**Subject: Section 8 of the Red Hill Administrative Order on Consent (“AOC”)
Statement of Work (“SOW”) Approval of Section 8.3 and Requirement to
Complete Additional Work**

Quantitative Risk and Vulnerability Assessment Phase 1 ("Risk Assessment")

Subject: Honolulu Board of Water Supply (BWS) Comments on ABS Consulting (ABS) Report "Quantitative Risk and Vulnerability Assessment Phase 1 (Internal Events without Fire and Flooding) dated November 12, 2018" and "Navy's Risk and Vulnerability Assessment Summary" and Cover Letter dated May 29, 2019 as per Red Hill Bulk Fuel Storage Facility (RHBFSF) Administrative Order on Consent (AOC) Statement of Work (SOW) Section 8

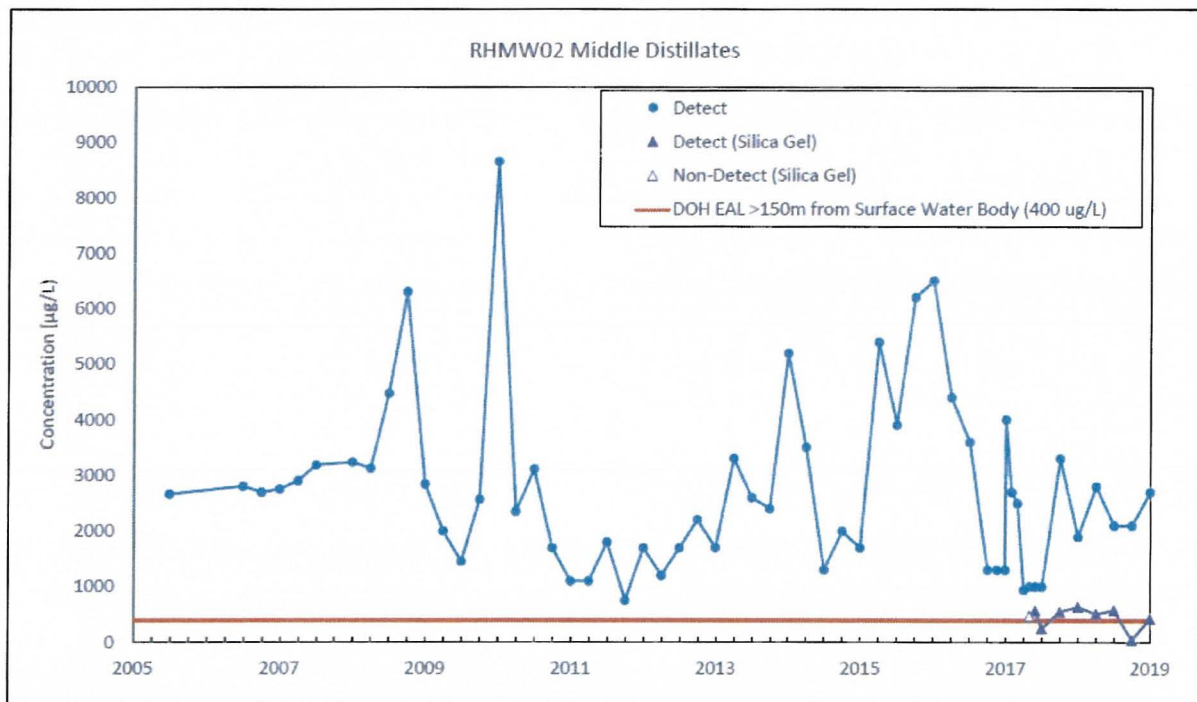
Groundwater data indicates that fuel continues to migrate to groundwater. As shown in the graph below, fuel constituents have been identified in groundwater samples collected from monitoring well RHMW02 since 2005. RHMW02 is the monitoring well located in the approximate center of the lower access tunnel and midpoint of the RHBFSF tank farm.
